SERVICE BULLETIN

M-1259

2009 FLHTCUTG TRUNK DOOR SEAL REPLACEMENT

The 2010 Trike trunk door seal will be used as replacement on 2009 Tri Glide model motorcycles. The 2010 model year part has enhancements to prevent water intrusion into the trunk area. This bulletin will provide instruction to correctly install the 2010 seal.

Figure 1. Trunk Door Seal

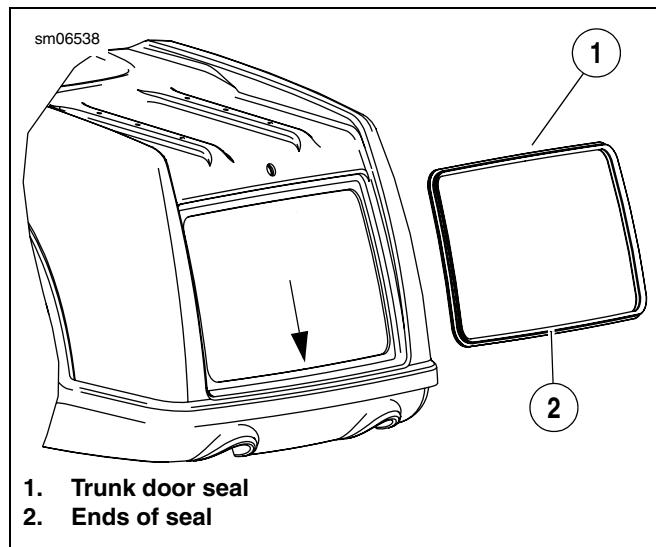
4. Peel back 3-4 in. (76-102 mm) inches of backing material.
5. See Figure 1. Beginning at the bottom-center of the opening, adhere the seal even with the edge of the opening as shown in Figure 2. Work only 3-4 in. (76-102 mm) at a time.

Figure 2. Cross Section of Gasket Placement

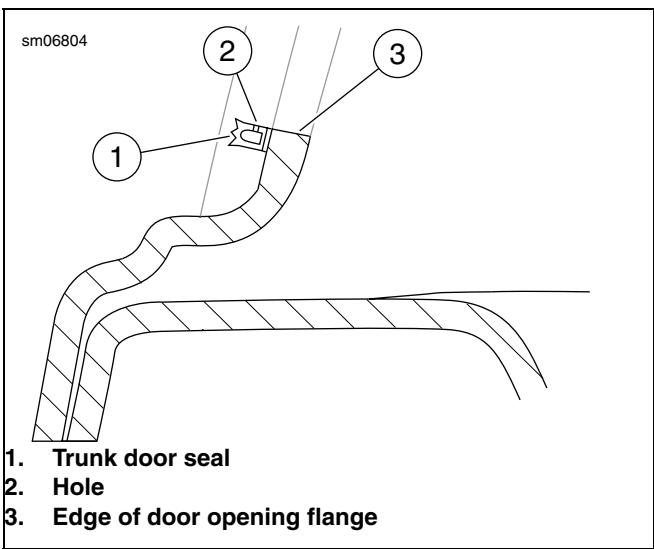
See Figure 2. Install the new seal (1) with the holes (2) toward the inside of the opening (3).

Figure 3. Adjust Latch Pins

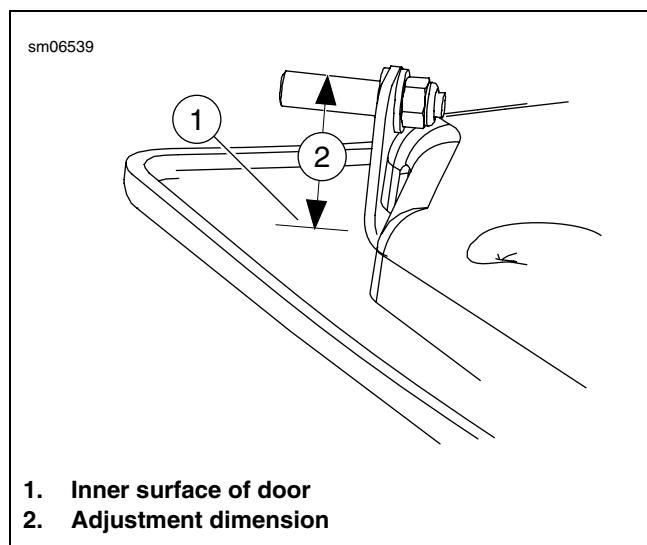
1. See Figure 3. Adjust the latch pins to 1.5 in. (38.1 mm) from upper edge of pin to the inner surface (1) of the door. Use a dial caliper to measure distance (2) near the end of the latch pin. Tighten nuts to 60-72 in-lbs (6.8-8.1 Nm).
2. Slowly close the door until the latch pins contact the latches. Both latch pins should contact the latches at approximately the same time. If necessary, reduce dimension (2) of the pin that contacted first until both pins contact at the same time.
3. Latch the trunk door and verify both sides are latched. If necessary, adjust the latch pins.
